Access Compliance Report

Public Rights-of-Way

(Curb Ramps)

Intersection ID: 27446	Main Street: BALLANTYNE_MEADOWS_DR	Cross Street: VALLEY_SPRING_DR	Location: E
ADA ID: 059A0513E54A	Ramp Type: PerpDiag	Initial Pass/Fail: Fail	Overall Compliance: No
Severity Score: 12.5			
Codes/Mitigation Info/Possible Solution		Field Measurements/Component Compliance

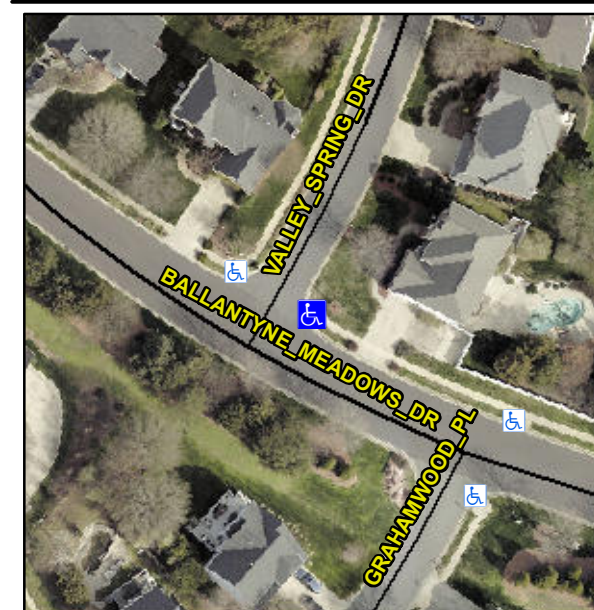
Not Found, R304.2.2

Compliance	Description	Data	Compliance	Description	Data
N/A	Ramp Length (in)	42.0	No	Ramp Slope (%)	11.5
Yes	Ramp Width (in)	48.0	Yes	Ramp XSlope (%)	1.1
N/A	Flare Type LT	N/A	N/A	Flare Type RT	N/A
N/A	Flare Slope LT (%)	N/A	N/A	Flare Slope RT (%)	N/A
N/A	Flare Traversable LT?	N/A	N/A	Flare Traversable RT?	N/A
N/A	Landing Length (in)	N/A	N/A	DWS Provided?	N/A
N/A	Landing Width (in)	N/A	N/A	DWS Contrast?	N/A
N/A	Landing Slope (%)	N/A	N/A	DWS Length (in)	N/A
N/A	Landing X Slope (%)	N/A	N/A	DWS Full Width?	N/A
N/A	Landing Curb? (Y/N)	N/A	N/A	DWS Offset (in)	N/A
N/A	Shared Landing?	N/A			
N/A	Gutter Ponding?	N/A	N/A	Gutter Slope (%)	N/A
N/A	Gutter Lip Ht (in)	N/A	N/A	Gutter X Slope (%)	N/A
N/A	Painted X Walk1?	No	N/A	Painted X Walk2?	No
	X Walk 1 Direction	To NW		X Walk 2 Direction	To SW
N/A	X Walk 1 Width (in)	N/A	N/A	X Walk 2 Width (in)	N/A
	X Walk 1 Slope (%)	0.6		X Walk 2 Slope (%)	2.8
	X Walk 1 X Slope (%)	2.0		X Walk 2 X Slope (%)	1.7

Remove & Replace Curb Ramp With Two New Directional Ramps or Equivalent.
